Access Compliance Report

Public Rights-of-Way

(Curb Ramps)

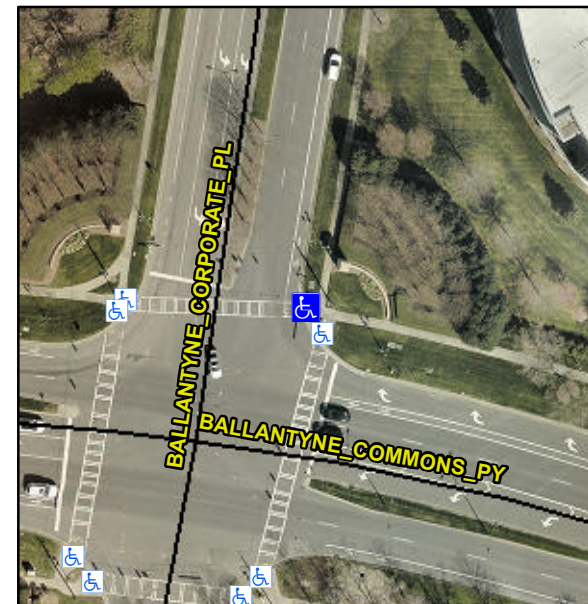
Intersection ID: 27452	Main Street: BALLANTYNE COMMONS PY	Cross Street: BALLANTYNE CORPORATE PL	Location: NE
ADA ID: C741DBD7C73F	Ramp Type: Directional1	Initial Pass/Fail: Pass	Overall Compliance: No
Codes/Mitigation Info/Possible Solution		Field Measurements/Component Compliance	
Severity Score: 2.75

R304.2.2-Perp, R304.3.2-Para, R305.1.4

Remove & Replace Entire Ramp.
